CALVERT CLIFFS UNIT NO. 1

Amendment No. 17  
License No. DPR-53

ATTACHMENT TO LICENSE AMENDMENT NO. 17

SAFETY EVALUATION BY THE OFFICE OF NUCLEAR REACTOR REGULATION  
SUPPORTING AMENDMENT NO. 17 TO FACILITY OPERATING LICENSE NO. DPR-53

Figure  
3-6

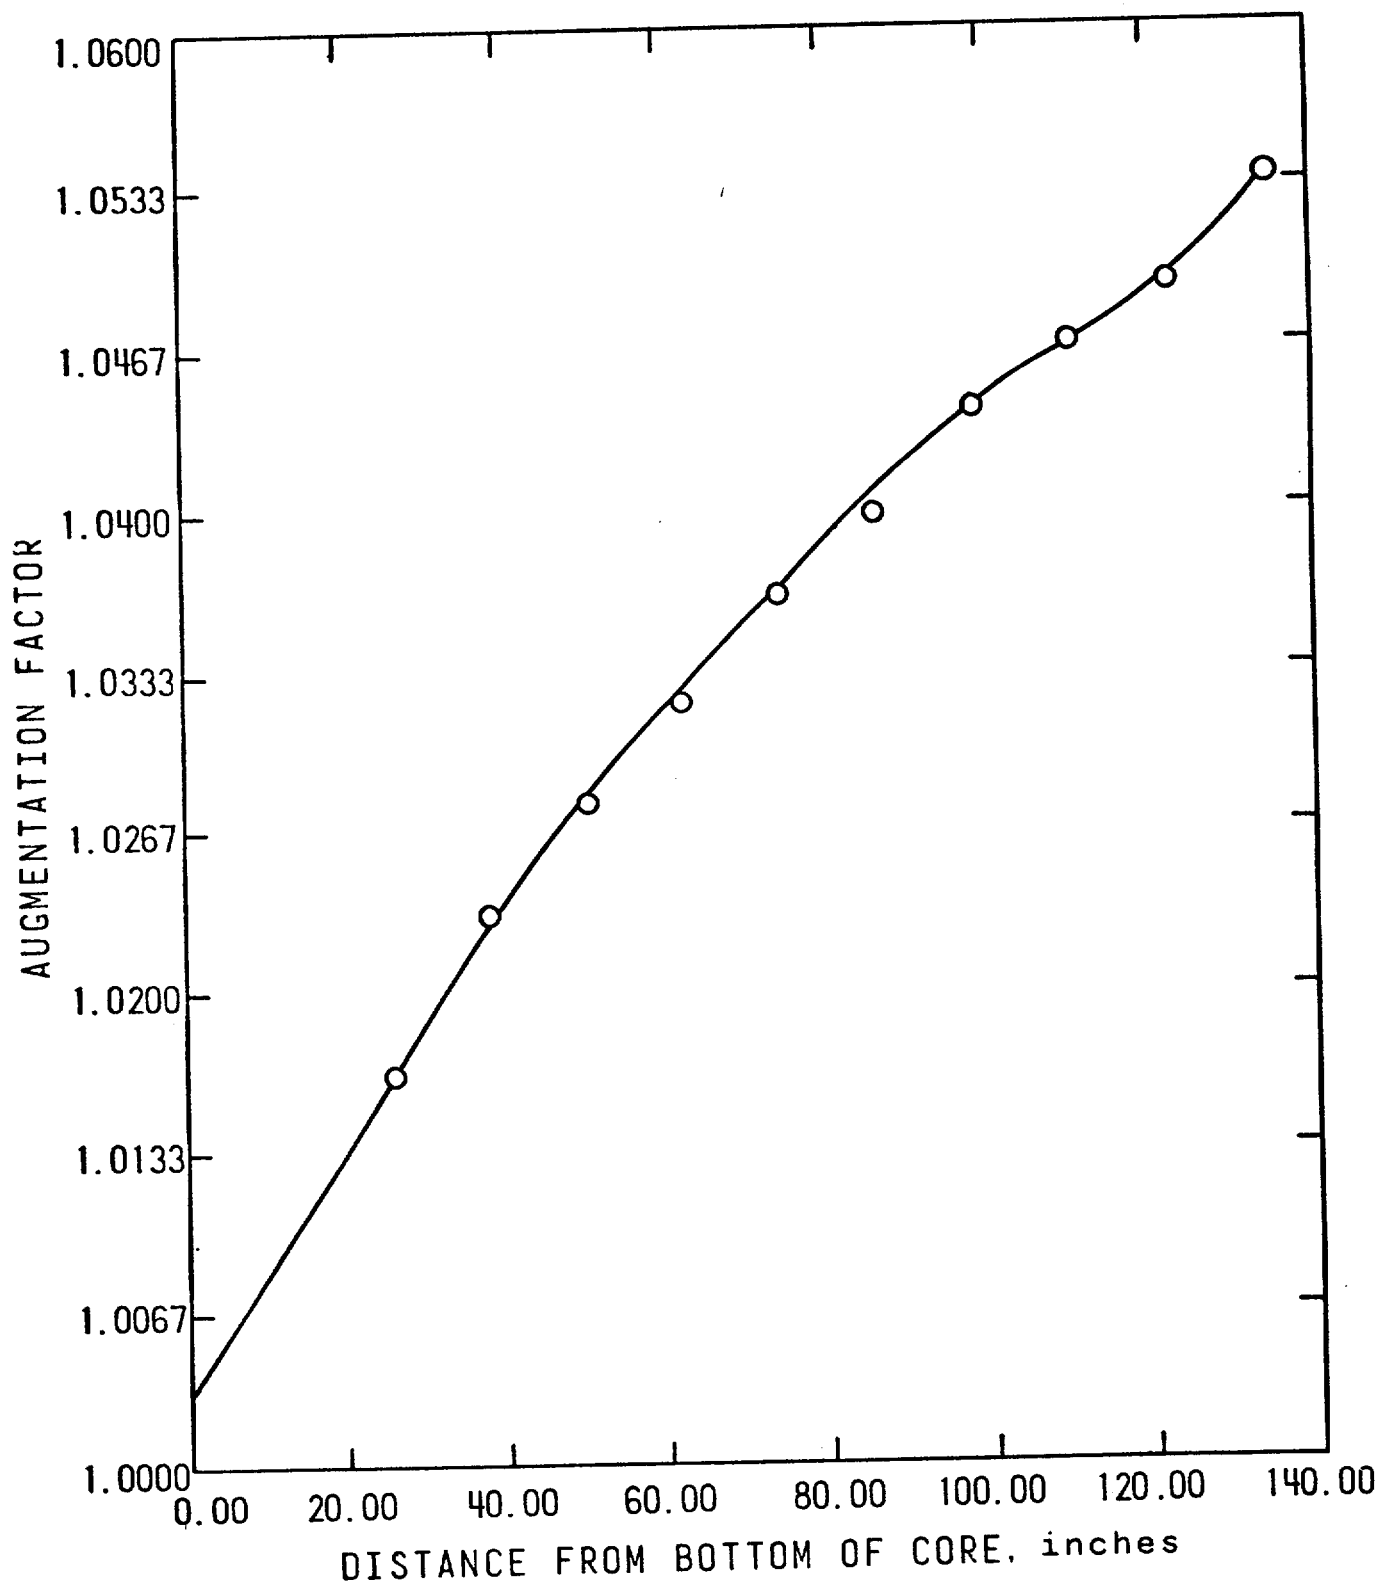
This amendment modifies the Technical Specifications to incorporate a revised Figure 3-6 "Augmentation Factors for the Calvert Cliffs Reactor". This results in an effective gain of approximately 0.7 kW/ft in the operating margin to the maximum allowable peak linear heat generation rate.

Replace page 3.10-20 (Figure 3-6) of the Appendix A portion of the Technical Specifications with the enclosed revised page 3.10-20.

We have reviewed the proposed curve of Figure 3-6. The proposed curve relating augmentation factor versus distance from the bottom of the core was generated using the methods described in the Combustion Engineering Topical Report, CENPD-139, for densification. The proposed curve is the same as the curve recently reviewed and approved by the staff for use in the Technical Specifications for Calvert Cliffs Unit No. 2. Augmentation factors were determined for various values of fuel burnup for the full life of the fuel in both Calvert Cliffs Unit Nos. 1 and 2.

The final proposed augmentation factor curve was defined as shown on Figure 3-6 by combining the most conservative values taken from both sets of calculations. We conclude that the change in augmentation factor as shown in Figure 3-6 has been determined using accepted and conservative methods and, therefore, is acceptable.
